A12 Chelmsford to A120 widening scheme

TR010060

DEVELOPMENT CONSENT ORDER CHANGE APPLICATION SURFACE WATER DRAINAGE STRATEGY ADDENDUM

Surface Water Drainage Strategy Addendum

Plate 4.1 Proposed design changes to the junction 19 northbound on-slip road compared with the design submitted in August 2022

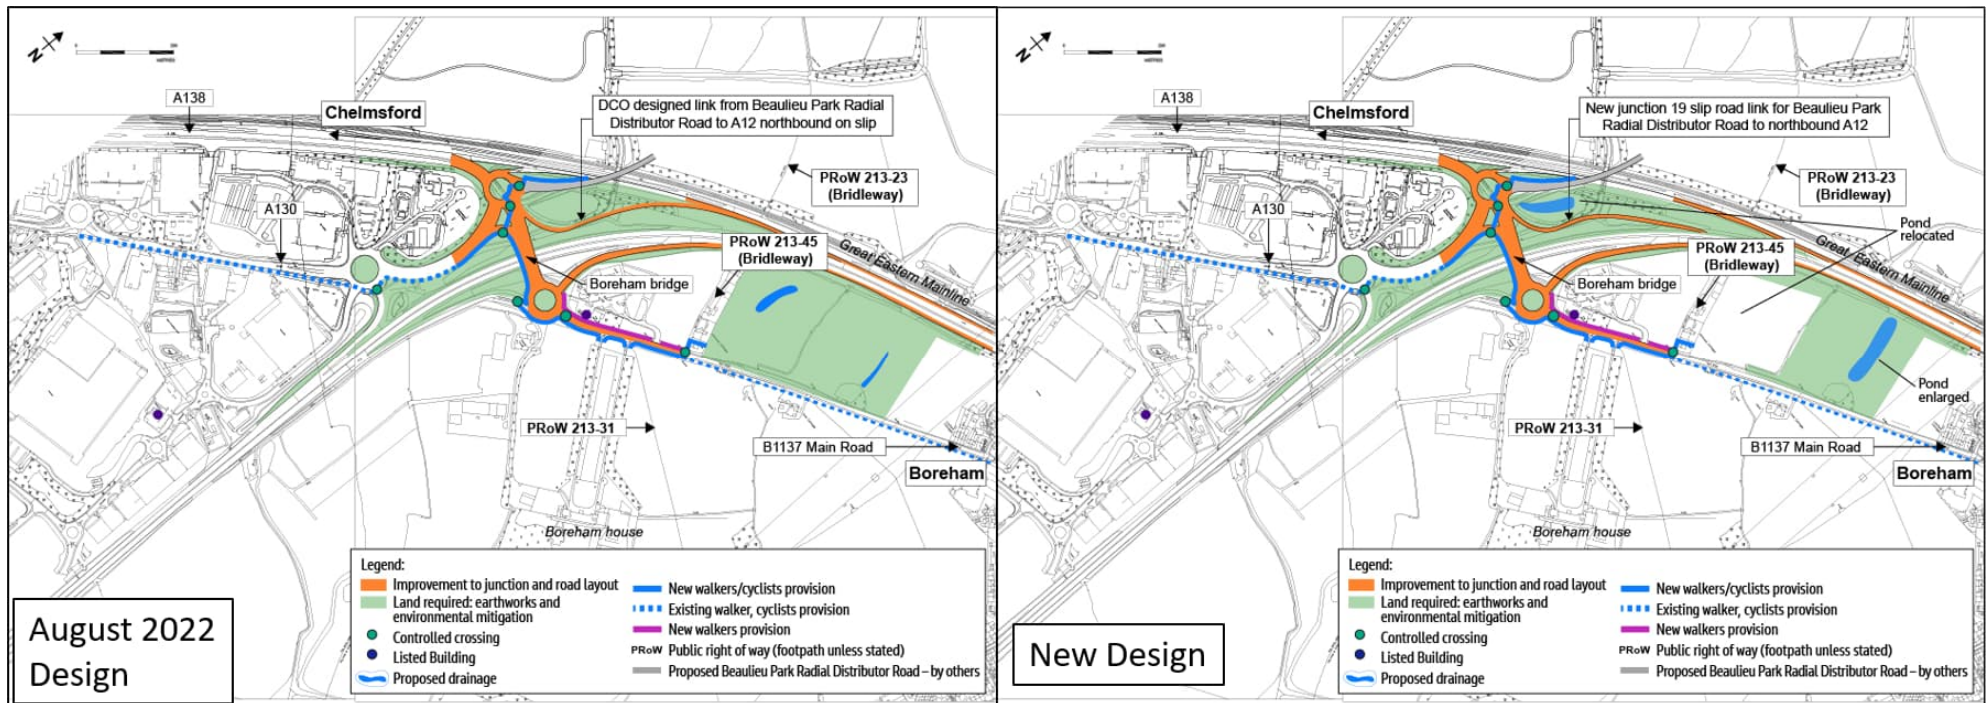
- 4.1.1 The proposed highway design change includes an alteration to the configuration of the northbound on-slip road at junction 19 to allow traffic to merge directly with the A12 mainline and thereby improving the safety to road users when joining the A12 northbound at junction 19. Refer to Section 2.2 of the ES Addendum [TR010060/EXAM/10.12] for further details on the proposed design change, including the detailed reasons as to why this design change is being proposed. Plate 4.1 presents a schematic comparison of the proposed change in highway design of junction 19 northbound on-slip road compared to the design submitted for the DCO application in August 2022.

Plate 4.2 Revised highway drainage design proposals in the vicinity of junction 19 compared with the design submitted in August 2022

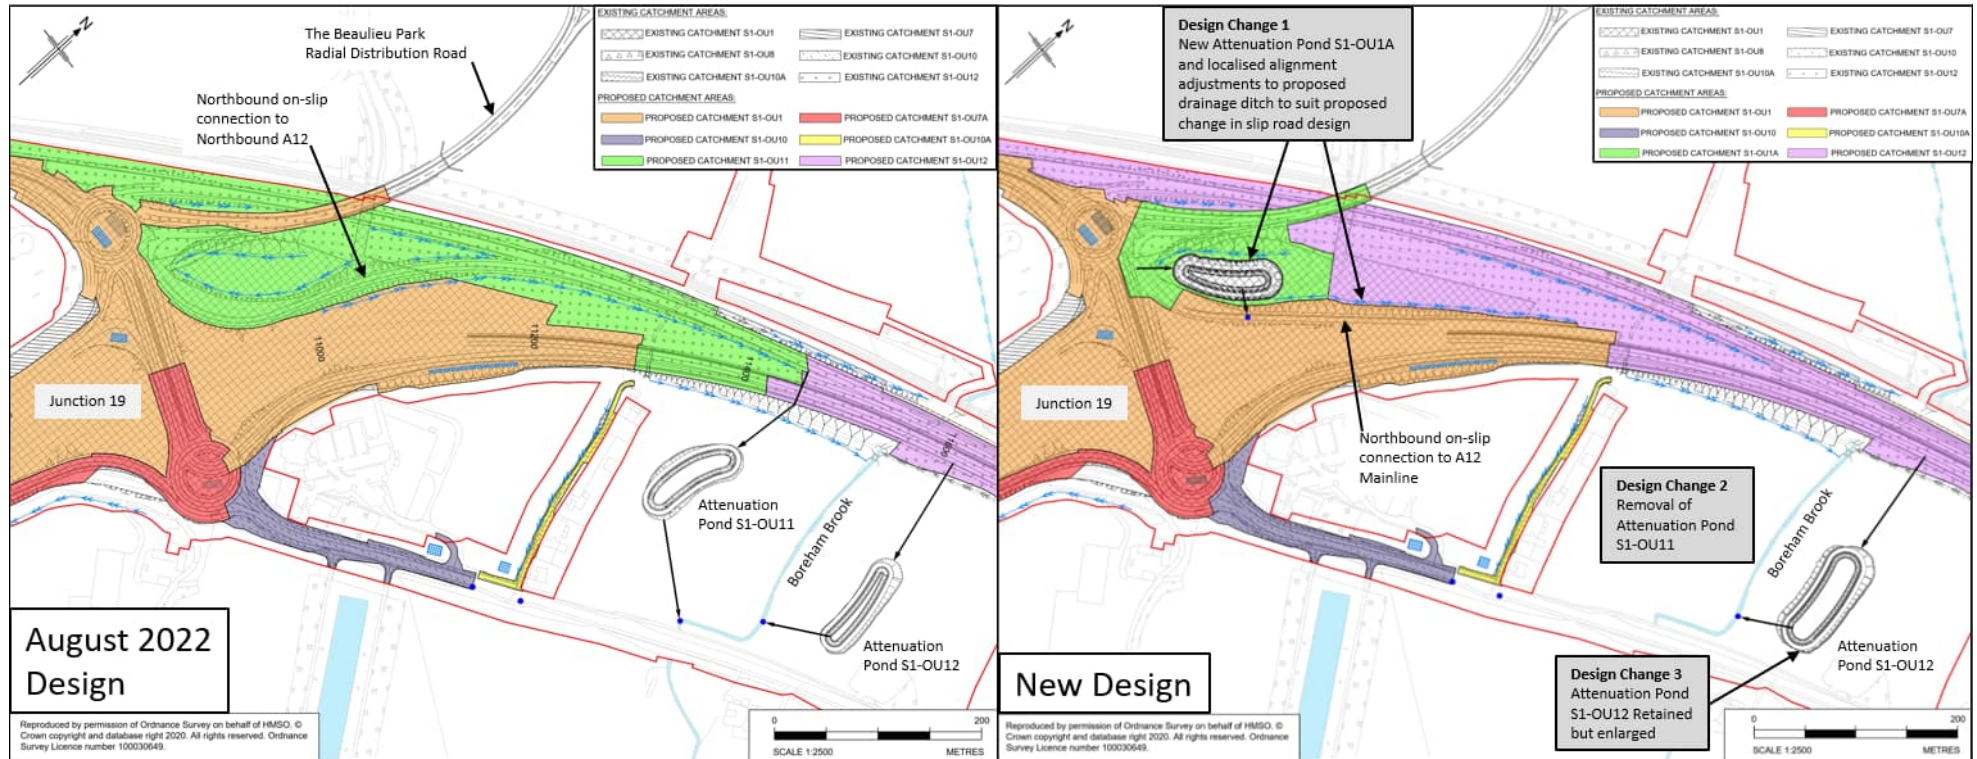
- 4.2.1 The proposed design change to the northbound on-slip road at junction 19 impacts the highway drainage design proposals submitted at DCO application. This is primarily due to the altered configuration of the new on-slip road design which now connects into the A12 mainline as opposed to the DCO application design which had a connection to the existing A12 northbound on-slip road. This design alteration to the slip road and its connection to the existing A12 mainline provides hydraulic constraints meaning that the highway drainage proposals in the vicinity of junction 19 that were provided within the Surface Water Drainage Strategy [APP-174] submitted at DCO application are no longer feasible.

- 4.2.2 The proposed highway drainage catchments affected by the above-described highway design change are proposed catchments S1-OU1, S1-OU11 and S1-OU12, located in the vicinity of junction 19. Refer to Sheet 2 of 21 of updated Drainage and Surface Water Plans in Map Book 1 [TR010060/EXAM/10.5], submitted with the Change Application for the revised highway drainage design proposals and the updated proposed catchment extents.

Reference to design change in Plate 4.2	New highway drainage design solution
Design Change 1	<p>New proposed S1-OU1A catchment attenuation pond – This new attenuation pond is proposed to attenuate the surface water runoff from the proposed highway drainage catchments associated with the northbound on-slip road at junction 19 (i.e. new slip road connection to A12 mainline) and the catchment associated with the realigned Beaulieu Park Radial Distribution Road. Additional online attenuation storage in the form of oversized pipes along the new slip road will also be required. The attenuated highway drainage runoff will discharge into the A12 mainline existing highway drainage system at controlled discharge rates. The design requirement for the new proposed S1-OU1A catchment attenuation pond and online attenuation storage due to highway and drainage design constraints is discussed in paragraph 4.2.4 to paragraph 4.2.8.</p> <p>Proposed drainage ditches – The proposed drainage ditches are retained although they require localised alignment adjustments to suit the design change for the new on-slip road connection to the A12 mainline.</p>

Design Change 2	<p>Proposed S1-OU11 catchment attenuation pond removal – This previously proposed attenuation pond has been removed.</p> <p>The highway drainage catchment portion associated with the previously proposed S1-OU11 catchment is now partially diverted to the proposed S1-OU12 catchment attenuation pond (i.e. Design Change 3 described subsequently within this summary table).</p> <p>Due to the highway design change in the on-slip road configuration (i.e. on-slip road connection now proposed to the A12 mainline), it is not practicable to retain the proposed highway drainage arrangement for the previously proposed S1-OU11 catchment attenuation pond. Therefore, the above-described affected proposed catchments are now proposed to be drained by the mitigation measures outlined in Design Change 1 above (i.e. the new proposed S1-OU1A catchment attenuation pond).</p> <p>The reduction in aforementioned proposed catchments associated with the S1-OU11 catchment has offered an opportunity to assess combining the S1-OU11 catchment with the S1-OU12 catchment (i.e. Design Change 3). The design development process for the combined S1-OU11 and S1-OU12 catchment is discussed in paragraph 4.2.9 to paragraph 4.2.11.</p>

Reference to design change in Plate 4.2	New highway drainage design solution
Design Change 3	<p>Proposed S1-OU12 catchment attenuation pond retention – It should be noted that there has been an increase in the attenuation storage volume for the proposed S1-OU12 catchment attenuation pond and associated footprint in comparison to the highway drainage design submitted in August 2022. This is because a portion of the highway drainage catchment associated with the S1-OU11 catchment is now draining to the proposed S1-OU12 catchment attenuation pond (i.e. Design Change 2 described above). However, the increased attenuation pond footprint is still contained within the proposed scheme Order Limits.</p>

- 4.2.4 The highway drainage design submitted at DCO in August 2022 included the previously proposed S1-OU11 drainage catchment associated with the northbound on-slip road at junction 19 (i.e. previously proposed on-slip road connection to existing A12 northbound on-slip road) and the realigned Beaulieu Park Radial Distribution Road. Refer to paragraphs 6.2.12 and 6.2.13 of the Surface Water Drainage Strategy [APP-174] which describes the proposed S1-OU11 catchment highway drainage submitted at DCO application.

- 4.2.5 The proposed design change in the slip road configuration (i.e. new on-slip road connection to the existing A12 mainline) requires the proposed highway drainage from these aforementioned new highway catchments to be drained into the existing A12 mainline highway drainage system and therefore they become part of proposed S1-OU1 catchment. It should be noted that the updated edge collection proposals for the above-described new on-slip road configuration include combined kerb drainage (CKDs) and filter drains which will discharge via carrier drains to the existing A12 mainline highway drainage system. The new re-configured on-slip road catchment will result in an increase in the volume of highway surface water runoff to be collected that drains into the existing A12 mainline highway drainage system contained within the proposed S1-OU1 catchment which was previously not accounted for in the highway drainage design submitted at DCO.

- 4.2.6 Further to the “Design Change 1” description in Table 4.1, an assessment has been undertaken through the hydraulic modelling of the revised proposed S1-OU1 catchment including the additional proposed S1-OU1A catchment areas draining into the existing A12 mainline highway drainage system due to the change in the on-slip road design configuration. The hydraulic modelling has confirmed that the discharge of surface water runoff from the additional proposed S1-OU1A catchment to the retained existing A12 mainline highway drainage system would exceed its conveyance capacity thereby resulting in larger exceedance flows and increased surface water drainage flood risk. This increased flood risk would be unacceptable as it does not comply with the highway drainage design criteria described in Section 3 of this SWDS Addendum and would also potentially put road users at increased risk of a

- 4.2.7 The additional surface water runoff arising from the additional paved area from the new proposed S1-OU1A catchment and the applied climate change allowance could not be sufficiently attenuated through the use of online attenuation storage in oversized pipework unless a significant amount of existing highway drainage network was upgraded. Oversized pipework would likely require larger diameter pipes that would increase the depth of the proposed highway drainage system, thereby preventing from its connection into the existing A12 mainline highway drainage system. Therefore, attenuation storage by means of oversized pipework only is considered to be an unfeasible option.

- 4.2.8 Due to the above-described design constraints associated with attenuation storage provision, the additional catchment associated with the on-slip road and the Beaulieu Park Radial Distribution Road is separated out to create a new drainage sub-catchment (i.e. the proposed S1-OU1A catchment). Attenuation storage is provided with a new proposed S1-OU1A catchment attenuation pond. Refer to updated Sheet 2 of 21 of Drainage and Surface Water Plans in Map Book 1 [TR010060/EXAM/10.5], submitted with the Change Application for the location of the new proposed S1-OU1A attenuation pond. A portion of the on-slip road catchment would need to be attenuated through online attenuation storage via oversized pipework due to highway geometry constraints (i.e. portion of the proposed highway extends beyond the proposed attenuation pond extent). The attenuated surface water flows are restricted prior to connecting back into the existing A12 mainline highway drainage system. These local interventions for the new proposed S1-OU1A catchment ensure that the proposed S1-OU1 catchment including its associated attenuation measures (e.g. proposed underground attenuation storage) submitted at DCO application in August 2022 remain largely unaffected.

- 4.2.10 Further to the “Design Change 2” description in Table 4.1, Hydraulic modelling has been undertaken for the combined drainage catchments (i.e. the reduced proposed S1-OU11 catchment and the adjacent proposed S1-OU12 catchment). The highway drainage catchment portion associated with the previously proposed S1-OU11 catchment is diverted to the proposed S1-OU12 catchment attenuation pond. The hydraulic modelling results confirm an increase in the attenuation storage volume requirements for the proposed S1-OU12 catchment and its associated footprint.

Plate 5.1 Revised highway drainage design proposals in the vicinity of the B1023 Kelvedon Road compared with the design submitted in August 2022 (Cluster Area 1)

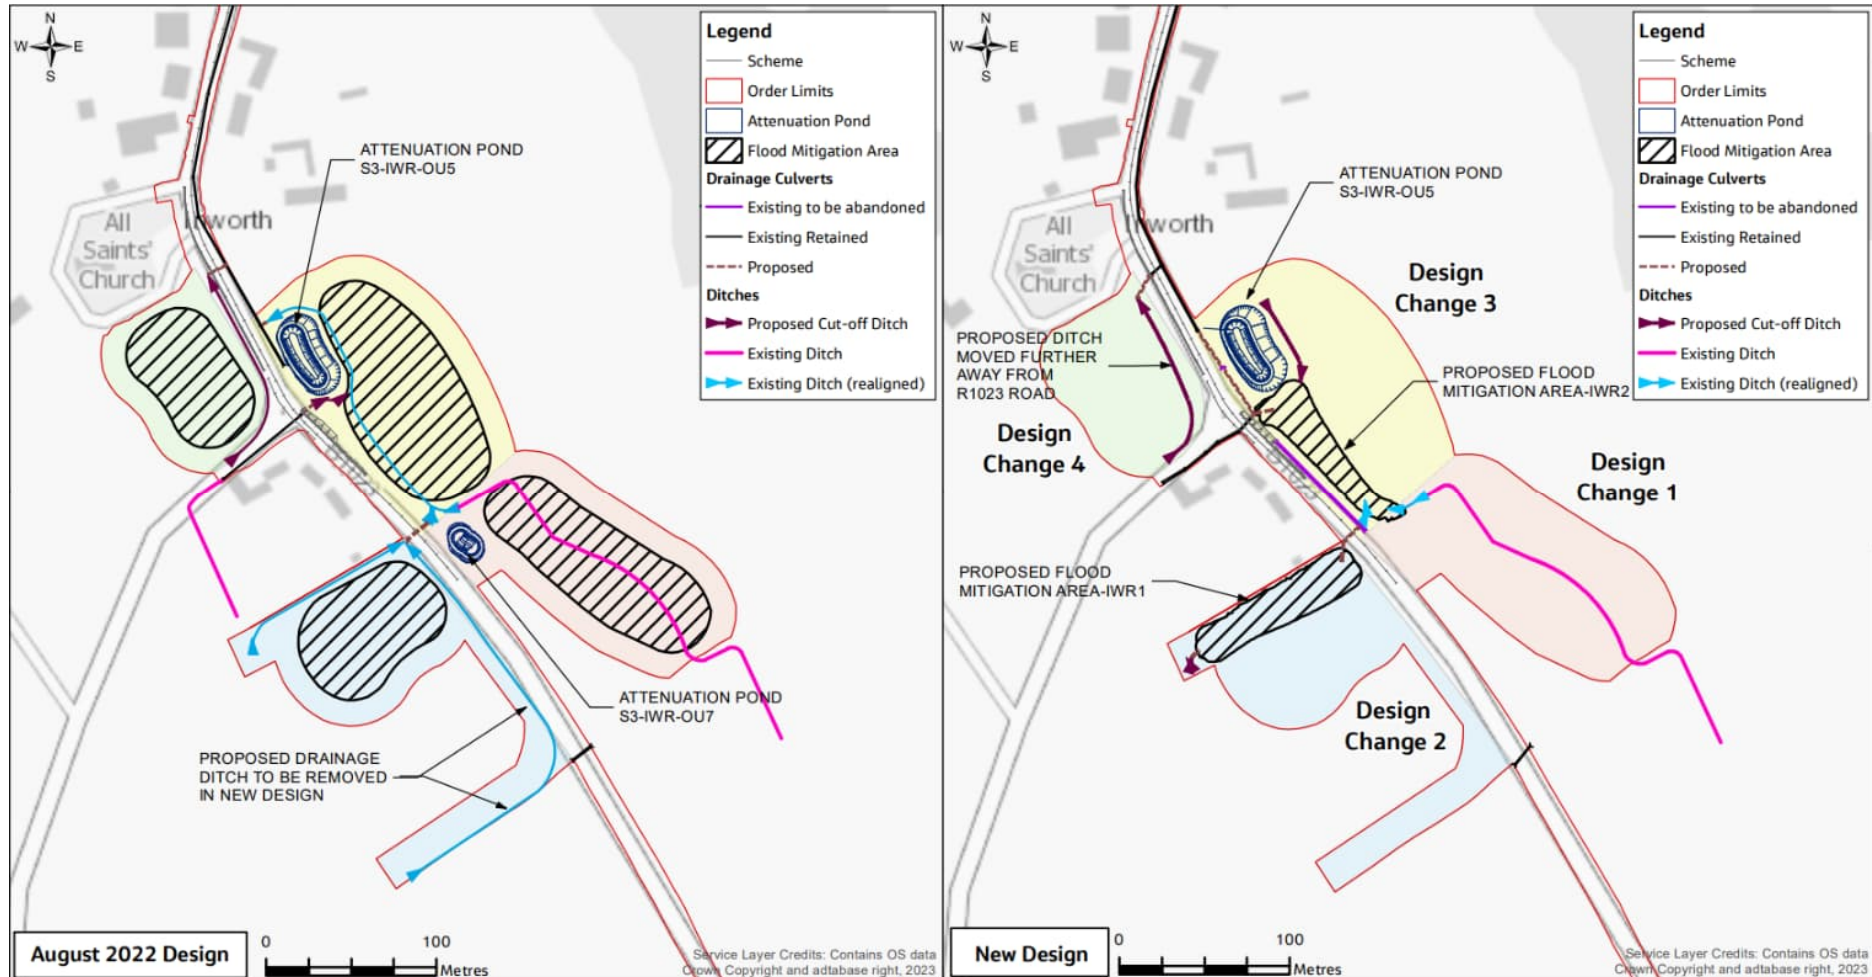
Landtake area reference from Plate 5.1	New highway drainage design solution
Design Change 1	Proposed S3-IWR-OU7 catchment attenuation pond removal – This previously proposed attenuation pond has been removed as there are no highway widening works within the proposed S3-IWR-OU7 catchment boundary. The design development process that has enabled the removal of this previously proposed attenuation pond is discussed in paragraph 5.2.6.
Design Change 2	Proposed drainage ditches adjacent to the B1023 Kelvedon Road at Inworth removal – The proposed drainage ditches that were considered previously as part of flood risk mitigation are no longer required and are removed as the additional drainage survey identified existing field drains/ditches that will be retained.
Design Change 3	Proposed S3-IWR-OU5 catchment attenuation pond retention – In light of the additional drainage survey information this proposed attenuation pond has been retained. The mitigation measure updates associated with this retained proposed attenuation pond are discussed in paragraph 5.2.7.

Design Change 4	The proposed drainage ditch is retained – The proposed drainage ditch is required to move further away from the B1023 Kelvedon road and is increased in size to capture the overland runoff from the upstream catchment which forms part of the overall solution for the watercourse flood mitigation measures in this area.
Note: Refer to FRA Addendum [TR010060/EXAM/10.16] for the design changes related to the watercourse flood mitigation measures.

- 5.2.6 The DCO application design included the proposed S3-IWR-OU7 catchment attenuation storage pond which would have required excavation over an existing high pressure gas main, the location of which was unknown during the DCO application stage design. The updated proposed highway drainage design solution has taken this constraint into account and developed a solution that enables the removal of the previously proposed S3-IWR-OU7 catchment attenuation pond. It should be noted that the proposed scheme proposes no highway widening works within the proposed S3-IWR-OU7 catchment boundary. The hydraulic modelling checks undertaken to assess the potential increase in rainfall intensity due to climate change has confirmed a minor increase in the surface water flow rates from this proposed catchment compared to the existing site condition. This minor increase in surface water flow rates would be mitigated through localised upgrades to the highway drainage system and/or flow adjustments with the adjacent proposed S3-IWR-OU5 catchment which ultimately discharges to the same receptor, namely Ordinary Watercourse 34.

- 5.2.7 The proposed S3-IWR-OU5 catchment attenuation pond is required to mitigate the increase in surface water runoff rates from the proposed highway widening works within the catchment boundary. It should be noted that the proposed S3-IWR-OU5 catchment attenuation pond also provides attenuation storage mitigation for the adjacent proposed S3-IWR-OU5A, S3-IWR-OU6 and S3-IWR-OU7 catchments. Separate attenuation storage mitigation measures are not feasible within these catchments due to spatial constraints. The combined discharge rates from the proposed S3-IWR-OU5, S3-IWR-OU5A, S3-IWR-OU6 and S3-IWR-OU7 catchments are less than the combined existing S3-IWR-OU5, S3-IWR-OU6 and S3-IWR-OU7 catchments allowable discharge
